Response To Comments

Michigan Disposal Waste Treatment Plant

Hazardous Waste Operating License and Permit

September 1999

Demographics Within Two Miles of Site: Figure 3

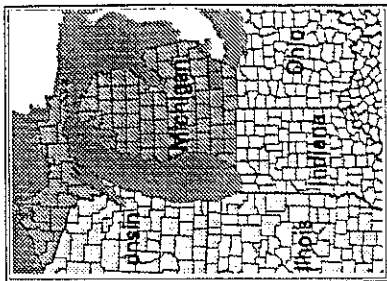
RESPONSE TO COMMENTS 3(a)-3(g):

In response to the above comments, the U.S. EPA conducted a demographic analysis for a two-mile area surrounding the WDI landfill and MDWTP, utilizing 1990 U.S. Census Bureau data. This analysis was computer generated by the U.S. EPA Region 5's Office of Information Services utilizing the Geographic Information System application and the 1990 U.S. Census Bureau TIGER/Line and STF3A files. A copy of the resultant data map is provided as **Figure 3** in the **Overview Chapter** of this *Response to Comments*.
